## ORIGINATION FORM

### Proposed Revisions to a Standard Plans Index

Index Number: 700-090

Index Title: Dynamic Message Sign Walk-In

LAST REVISION	REVISION	DESCRIPTION:	 FY 2022-23 STANDARD PLANS	DYNAMIC MESSAGE SIGN WALK-IN	INDEX 700-090	SHEET 1 of 5
11/01/22

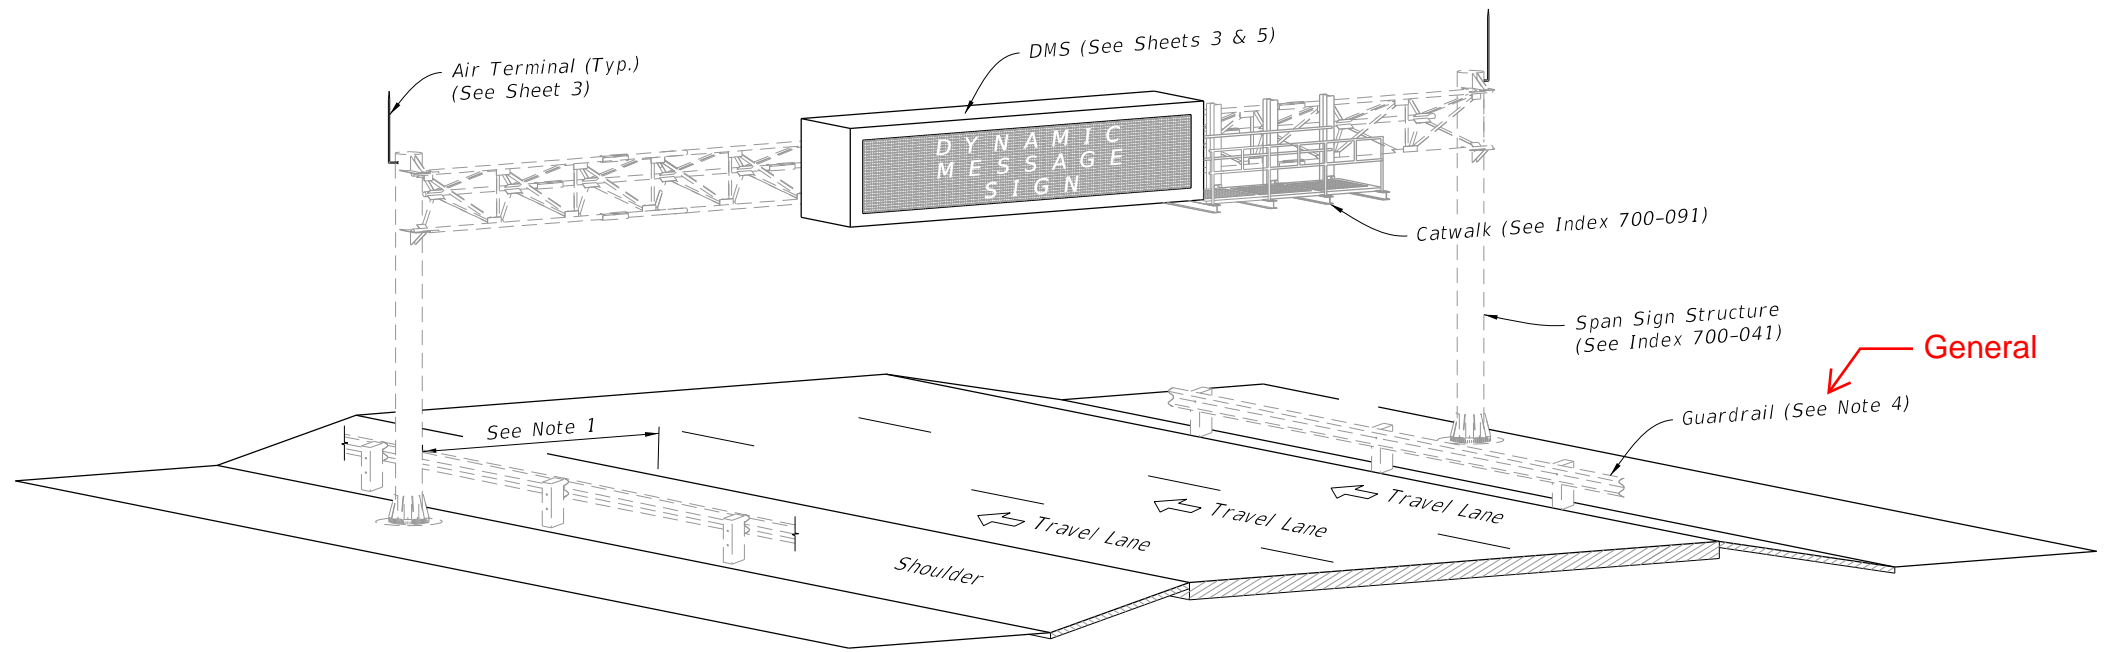
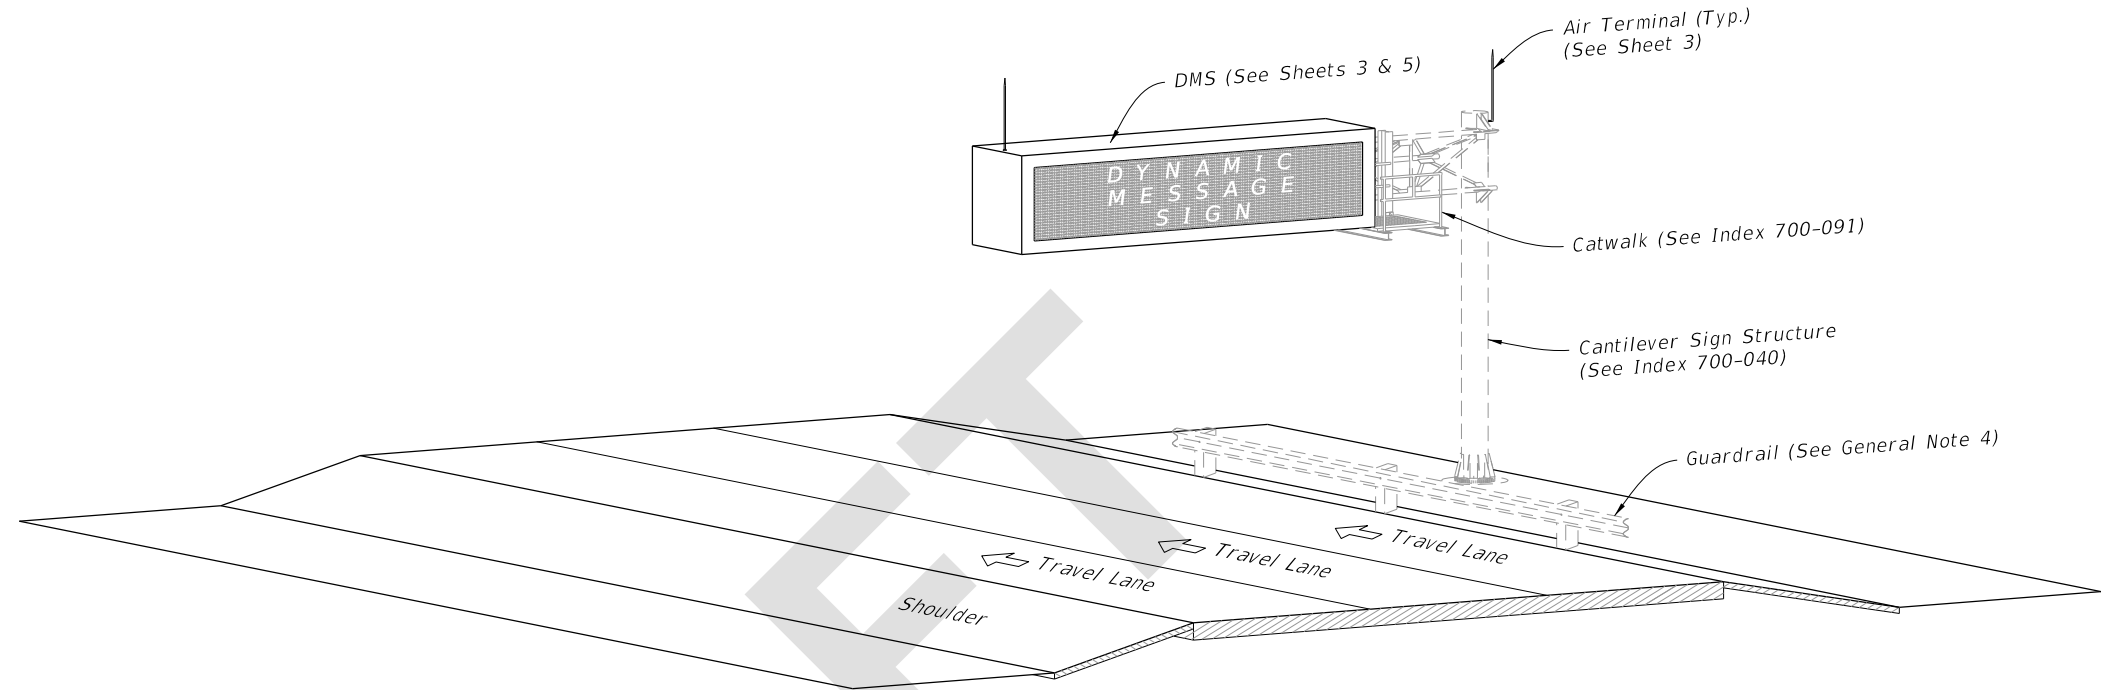
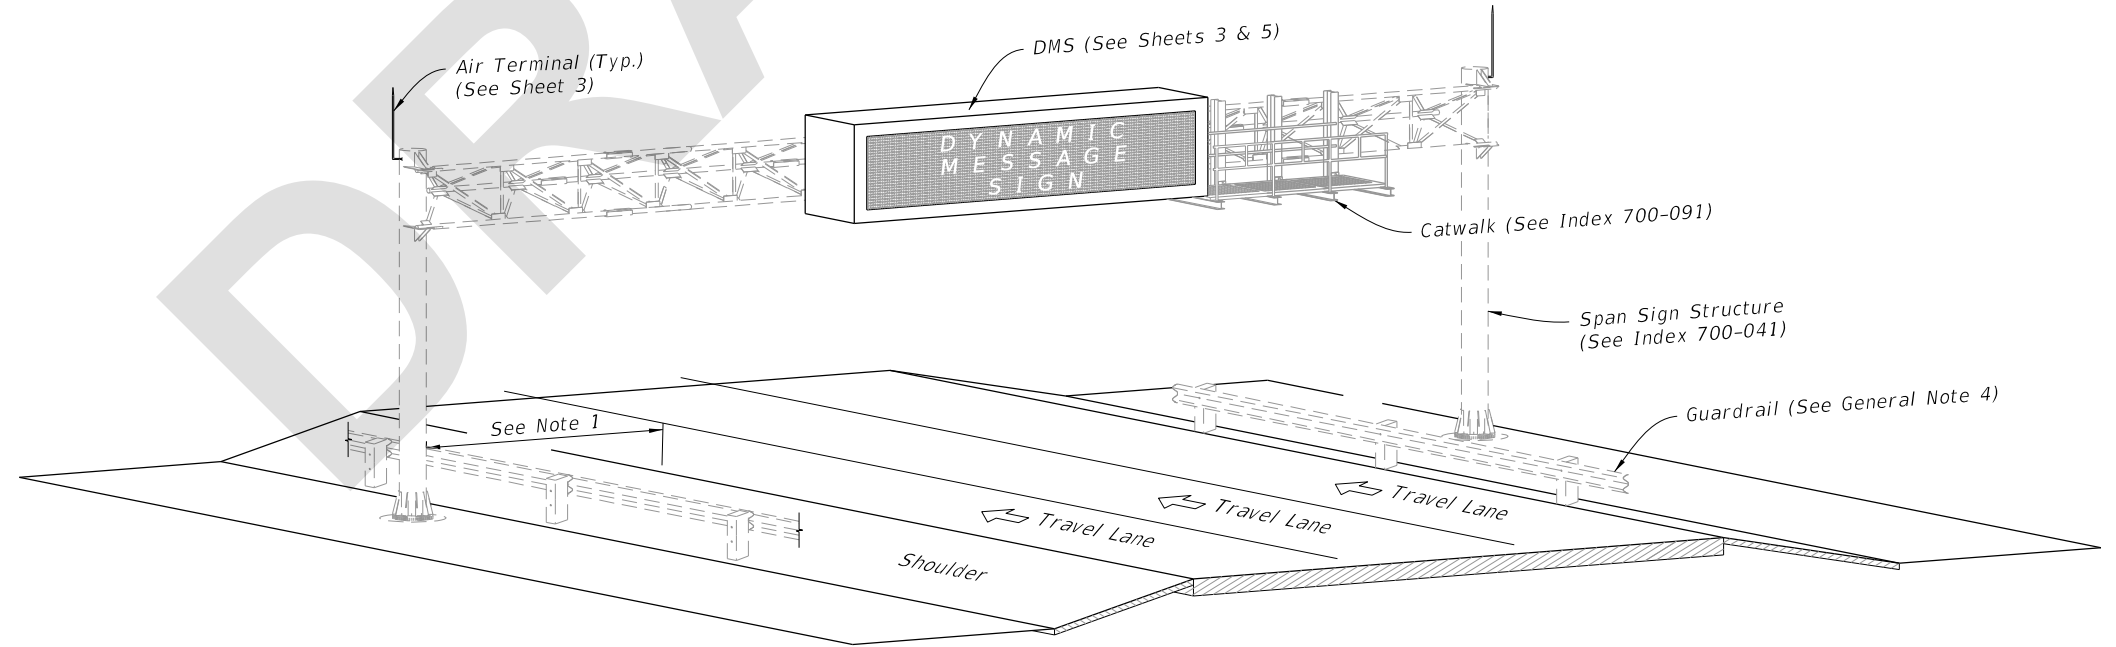
Updated General Note 1 - "Meet the requirements of Specification 700."; Deleted Note 5; Renumbered General Notes.

- 1. ~~Work this Index with Specification 700.~~
- 2. Furnish and install the Dynamic Message Sign (DMS), sign structure in accordance with Index 700-040 or 700-041. Locate foundations at locations shown in the Plans.

- 5. ~~Materials:~~
  - A. ~~Sign Mounting Components:~~
    - a. ~~Aluminum Structural Shapes: ASTM B221, Alloy 6061-T6~~
    - b. ~~Vertical Hangers: ASTM A704, Grade 36~~

**UPDATED NOTE: Meet the requirements of Specification 700.**

**DELETED**

**GENERAL COMMENT: Material information was deleted. Information is either already covered in Standard Specifications OR will be added to Section 700, 962 or 965 in conjunction with these revisions.**

1. Meet the requirements of Specification 700.
2. Furnish and install the Dynamic Message Sign (DMS), sign structure in accordance with Index 700-040 or 700-041. Locate foundations at locations shown in the Plans.

5. Installation:
  - A. See project requirements for location of DMS Cabinet.
  - B. Field Adjust pole-mounted DMS cabinet height to achieve best access for maintenance personnel given site condition as directed by the Engineer. Avoid conflicts with stiffeners, handhole and maintenance of anchor bolts.
